Re: March 2018 Preliminary Draft Report
2017 Inventory of Renewable Energy Generators Eligible for the Maryland RPS

In response to the Power Plant Assessment Division of Maryland's Department Natural Resources Request for Comments on the above referenced Draft Report, Brookfield Renewable ("Brookfield") is pleased to submit the following comments and recommendations.

**Chart 1
Existing Non-Solar Certified Tier 1 Generation Capacity (MW)²**

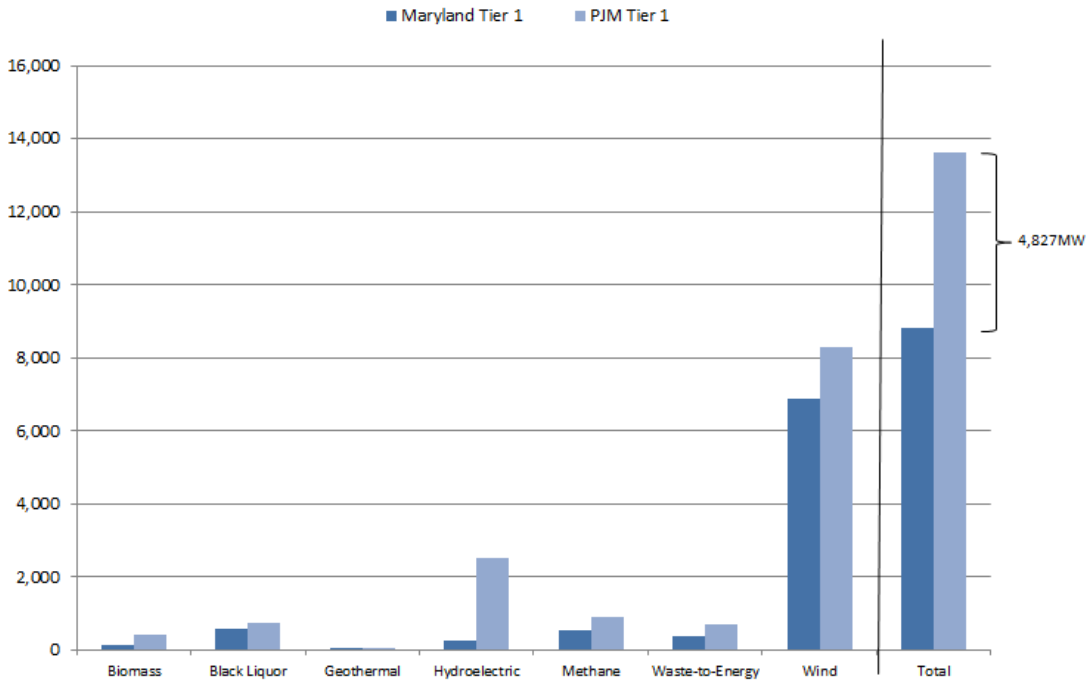
1. The supply of available resources includes only those resources that are certified as Tier 1 eligible in Maryland in PJM-GATS, thereby underestimating the actual PJM supply.

This assumption is problematic as it causes a significant quantity of Tier 1 resources to be excluded from the supply analysis. Resources that are eligible under Maryland’s program requirements may instead choose to register in other PJM states where their RECs are sold. In addition, differences in resource eligibility criteria may cause some resources to be considered Tier 1 eligible in some PJM states despite being excluded from Maryland’s Tier 1 program. Nevertheless, these resources are available to contribute to the RPS programs of other PJM states and should be included in the analysis to have an accurate account of the available supply. Brookfield’s analysis suggests that changing this one assumption alone could result in almost 5,000MW of additional existing Tier 1 supply.

**Chart 2
Brookfield’s Analysis compared to
Exeter’s Analysis of Non-carve-out Tier 1 Supply and RPS Obligation
(2018-2030) (GWh)**

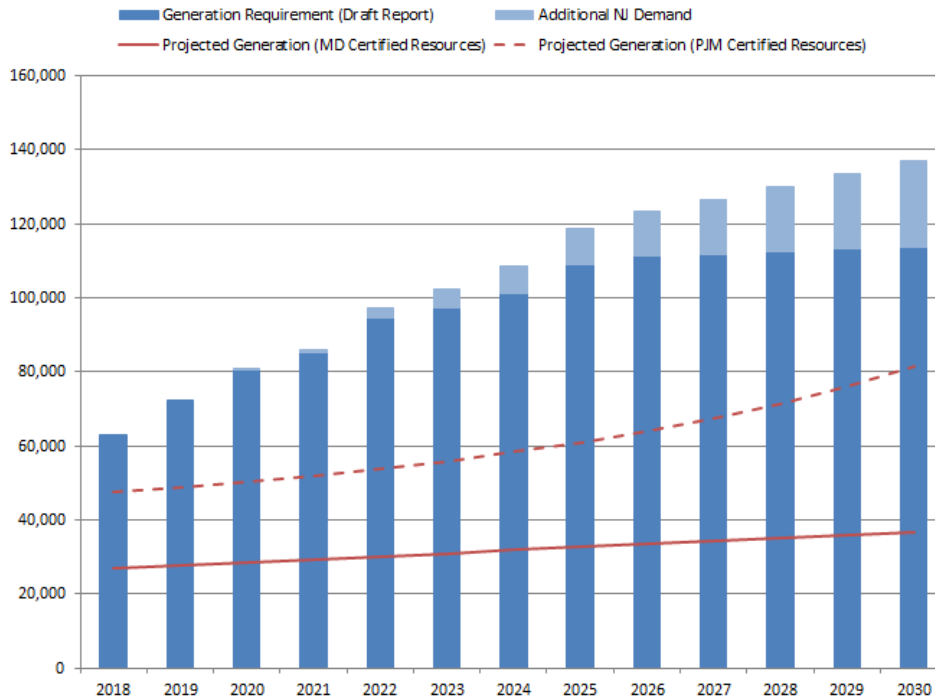
Brookfield’s analysis of PJM certified resources, represented by the dashed red line in Chart 2 above, reveals a larger existing supply (an additional 20TWh in 2018) as compared to Exeter’s analysis, represented by the solid red line. This significantly reduces the annual growth rate of renewable energy generation required for all PJM states to meet their RPS obligations in 2020 to approximately 20 percent, rather than 46 percent in Exeter’s Draft Report. Nonetheless, Maryland and other PJM states still cannot collectively meet their non-carve-out Tier 1 requirements.

Chart 3
Brookfield’s Adjusted Baseline as compared to
2018-2019 Legislative Initiatives
2030 Obligation (GWh)

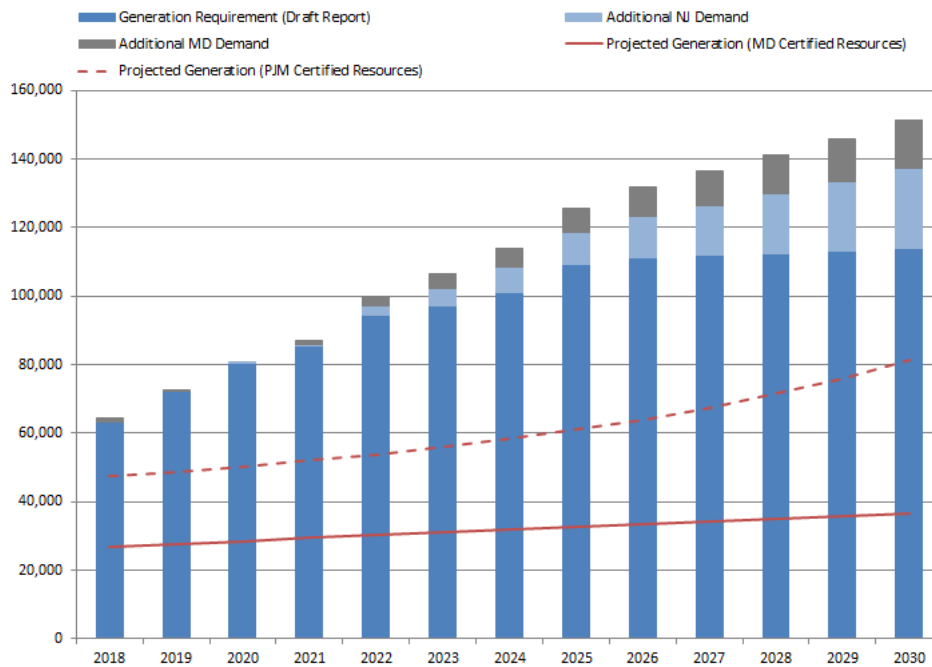
In the Draft Report, Exeter models an RPS target of 50 percent by 2030 to measure potential impacts of an expansion of Maryland’s RPS requirements, should the State Legislature approve such an increase⁴. Adding the 50 percent by 2030 target to Brookfield’s preceding non-carve-out Tier1 supply analysis results in an additional 14TWh of renewable demand in PJM in 2030.

Chart 4
Expanded Tier 1 Eligibility for Hydropower⁹

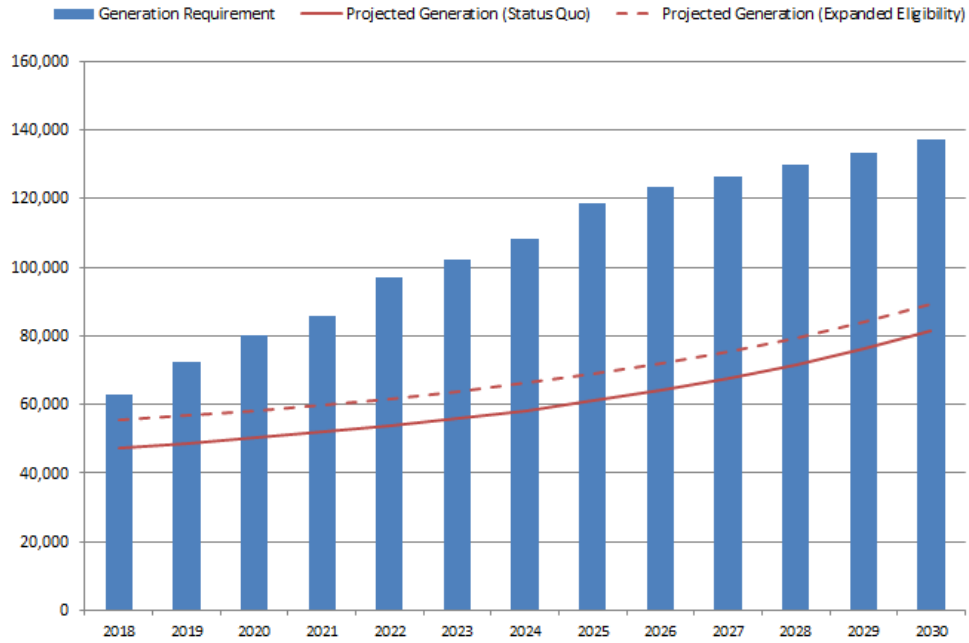
Brookfield recommends that Exeter assess the value of extending eligibility to existing hydropower resources that are not eligible under Maryland's current Tier 1 program due to the 30MW cap on hydropower facilities.

Currently over 2,000MW of hydropower is certified as Tier 2 in Maryland. Transitioning these resources to Tier 1 would help address anticipated deficiencies in non-carve-out Tier 1 resources in PJM, while maintaining incentives for the build out of new renewables. Brookfield's modeling suggests that expanding Tier 1 eligibility to include 2,000MW of additional hydropower would reduce the supply gap by about 8 percent annually on average from 2018 to 2030.

Chart 5
Annual Ratepayer Savings from
Expanded Tier 1 Eligibility for Hydropower (\$)

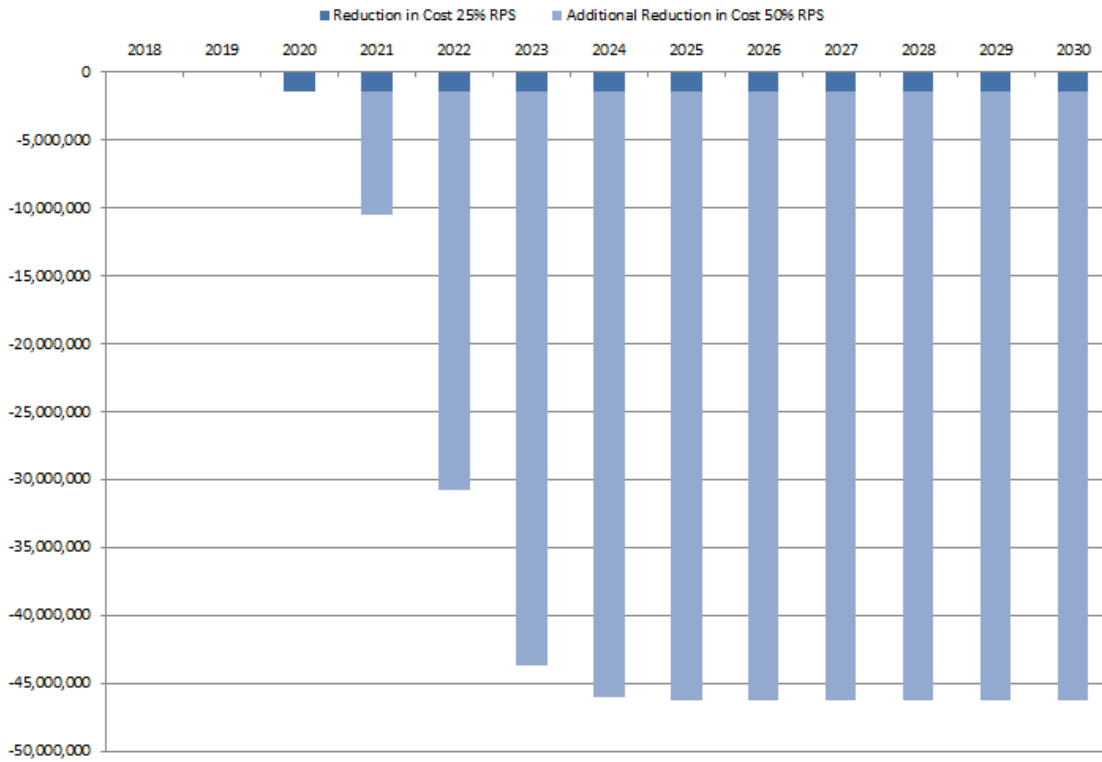
This one change alone could produce almost \$16 million in ratepayer savings by 2030, with savings potentially increasing to over \$400 million over the same period if Maryland’s RPS is expanded to 50 percent.
